September 19, 2025

## **ADDENDUM NO. 1**

### **DNR-250004 GREAT COUNCIL OBSERVATION TOWER**

1587 US-68,  
Xenia, OH 45385

2 FIRST FLOOR PLAN - POWER AND SYSTEMS  
1/4" = 1'-0"

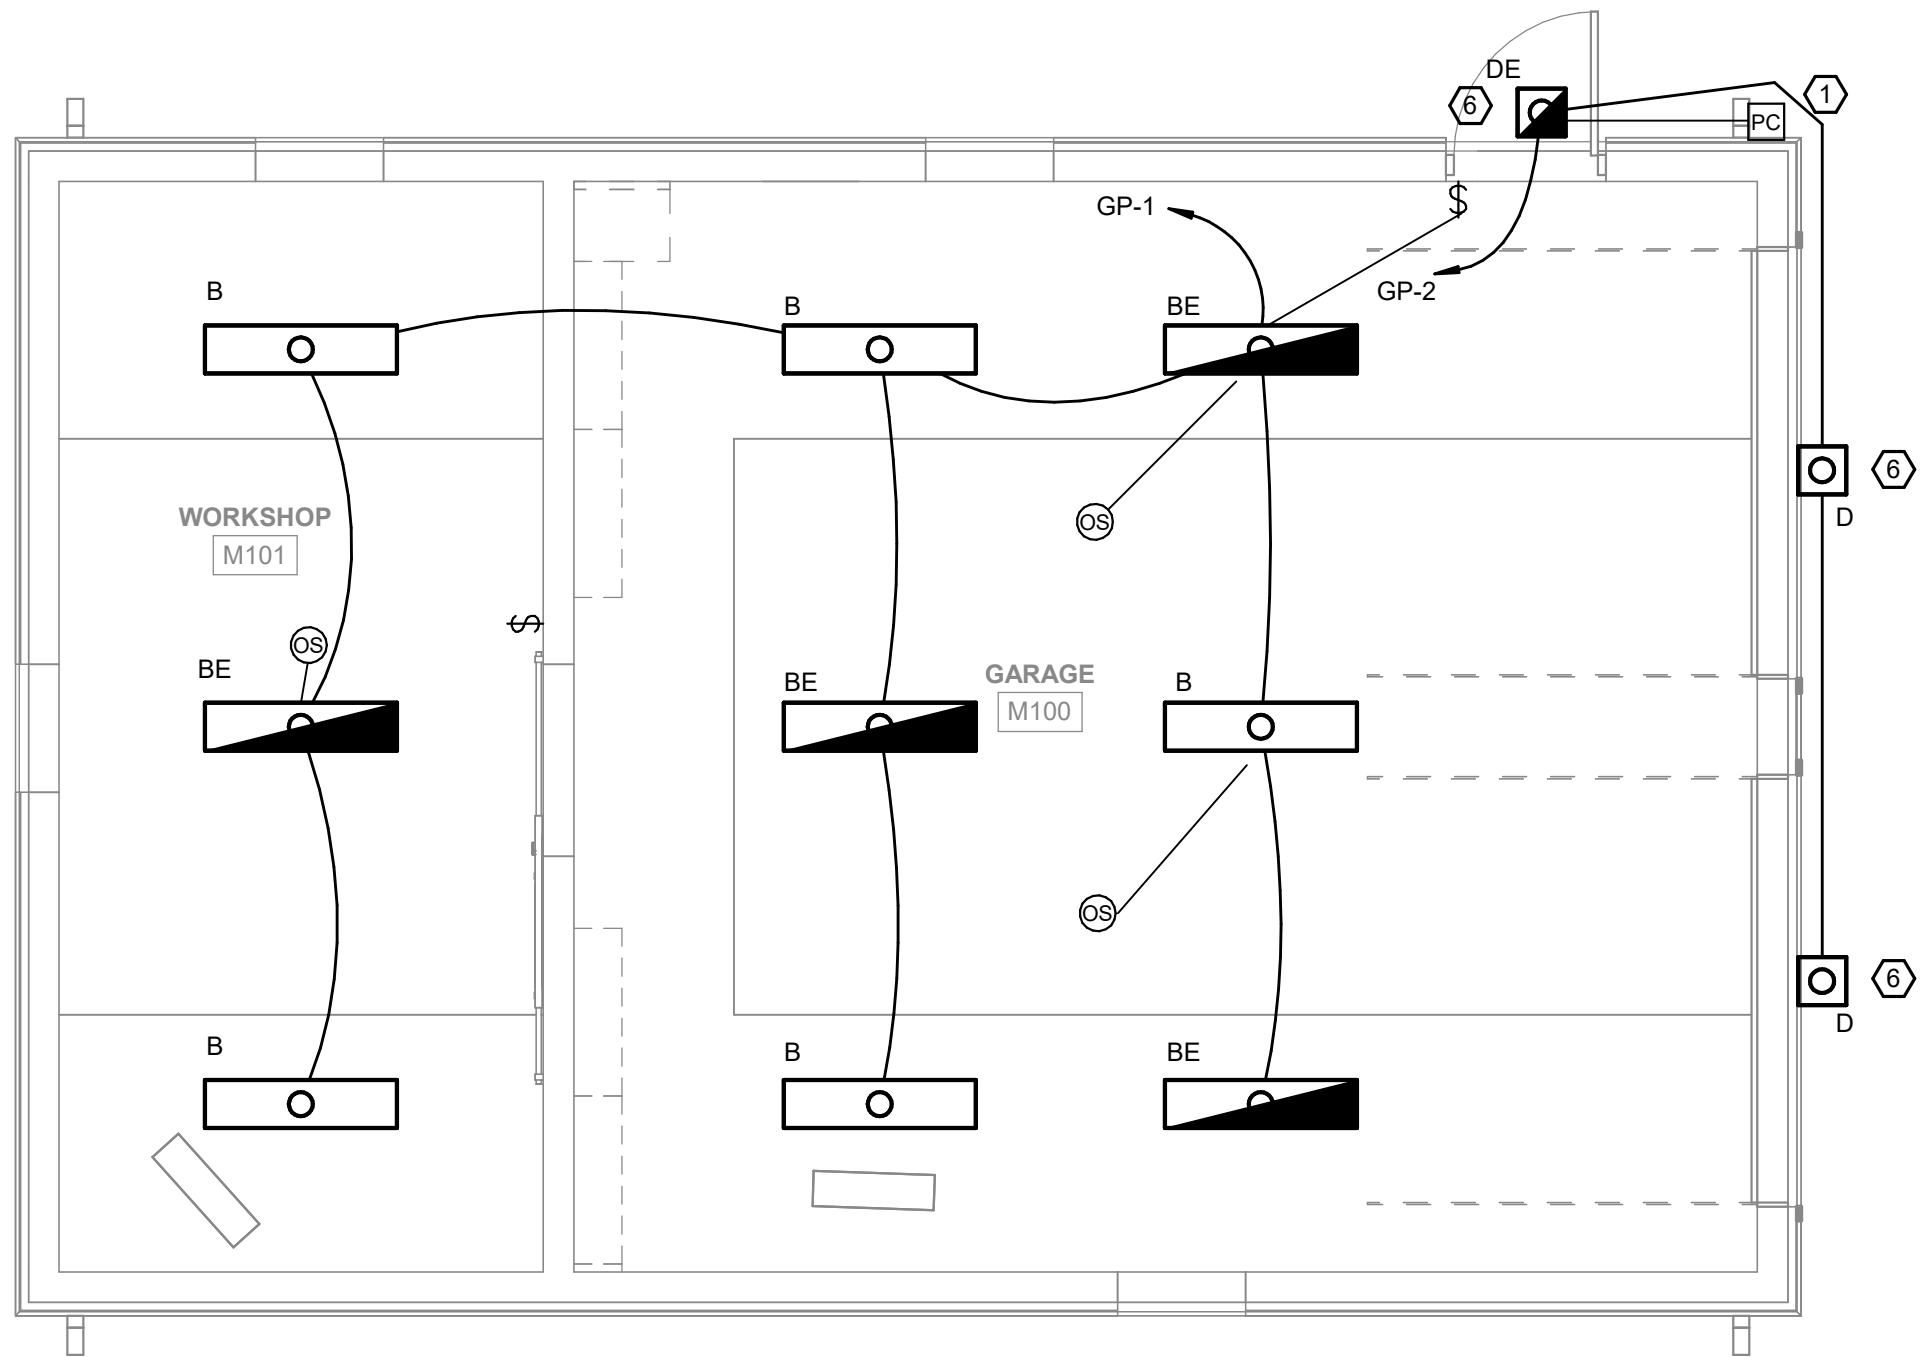
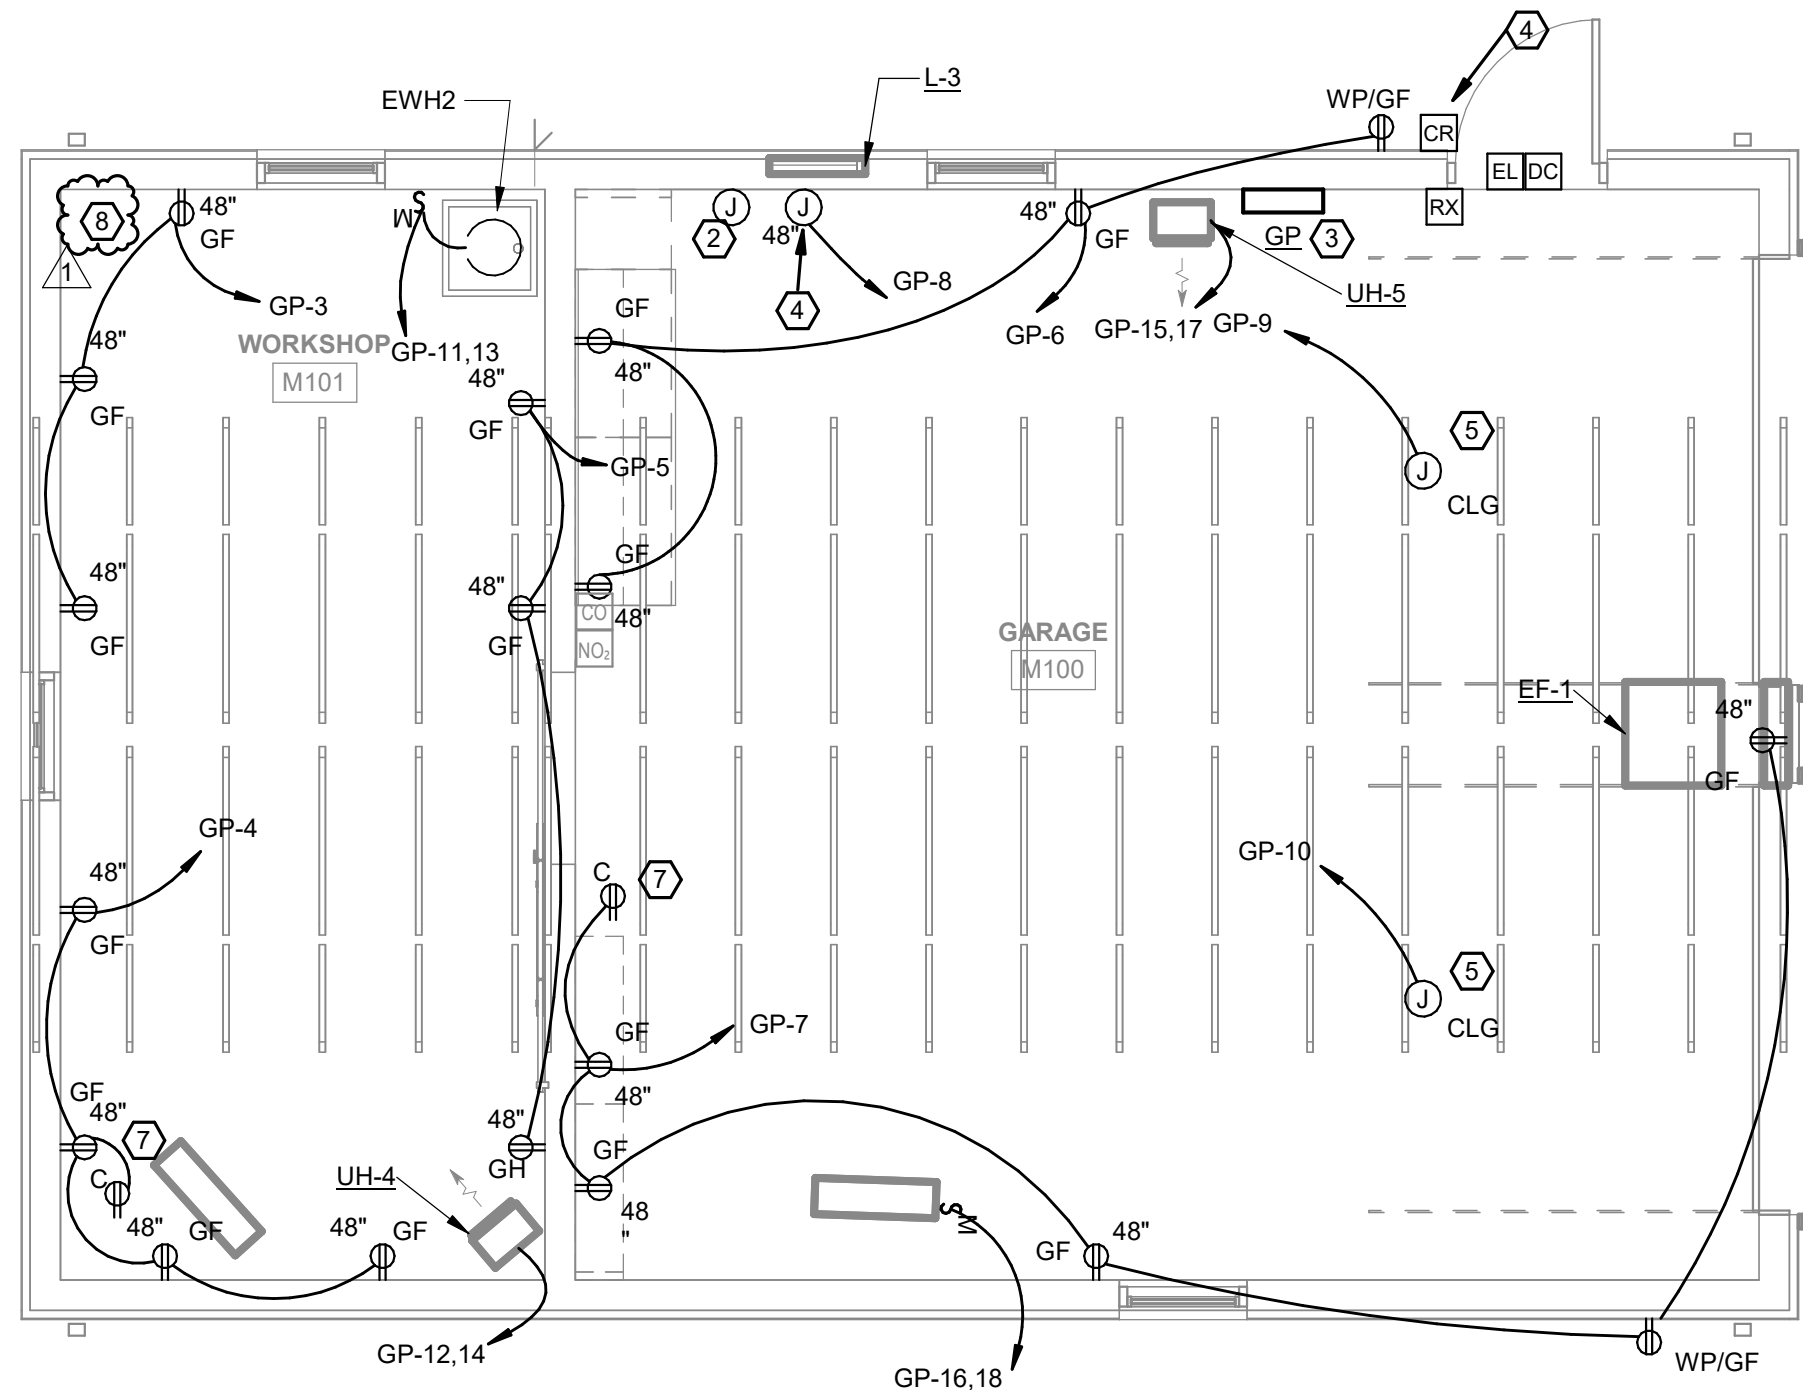
**ITEM 18 E201 – FLOOR PLAN - ELECTRICAL**

Added Keynote note 8 to read, “APPROXIMATE LOCATION OF OWNER COMMUNICATION EQUIPMENT. STUB CONDUITS UP IN CORNER OF ROOM. CONFIRM EXACT LOCATION WITH OWNER PRIOR TO ROUGH-IN.”

Revised keynote 5.

1 SINGLE-LINE DIAGRAM - ELECTRICAL  
NTS

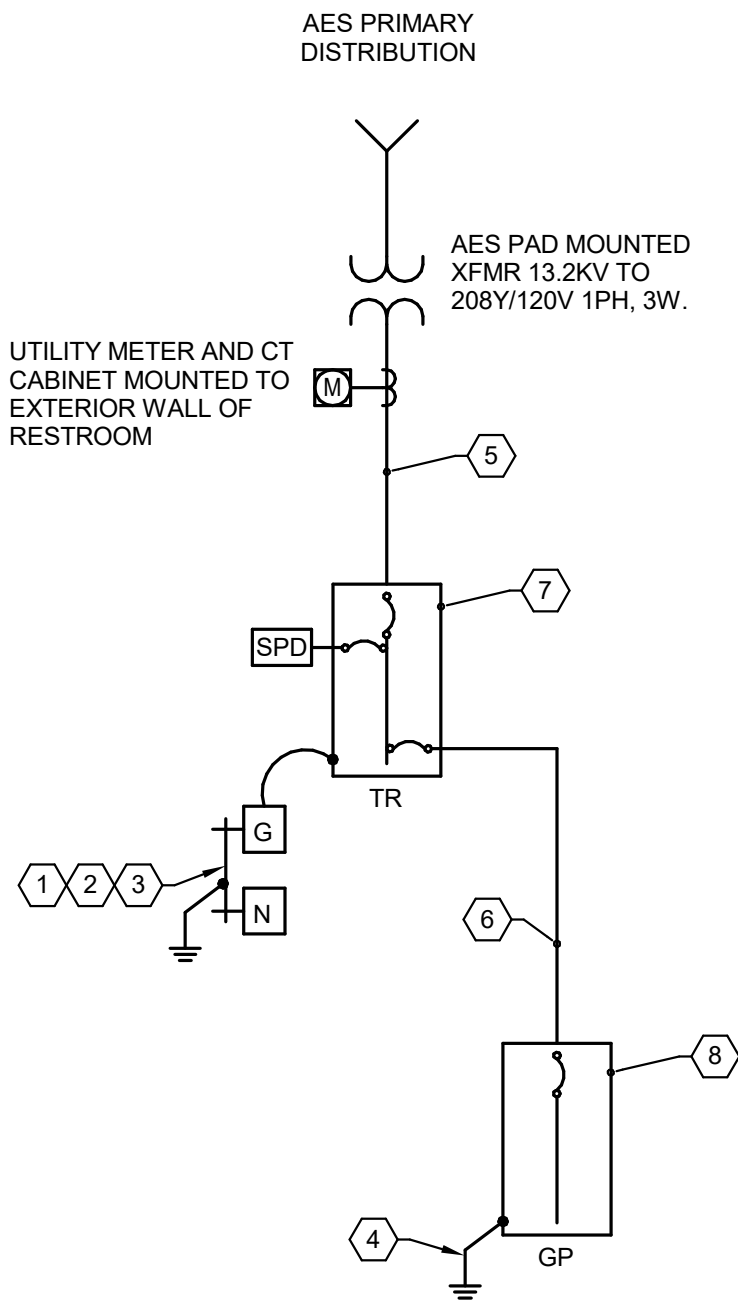
**ITEM 46 Q: SITE PLAN E002- NOTE 11. PROVIDE 3#3/0, 1#6(G)-2"C FROM PANEL "TR" UNDERGROUND TO PANEL "GP" DIAGRAMS- ELECTRICAL E701- NOTE 6. PROVIDE 3#250KCMIL (AL), 1#2(G)-3"C. FROM PANEL "TR" IN RESTROOM PLUMBING CHASE TO PANEL "GP" IN GARAGE. WHICH ONE ARE WE TO FOLLOW FOR INSTALLATION? OR IS THIS TO OUR DISCRETION?**

A: See revised drawings for Addendum 01.
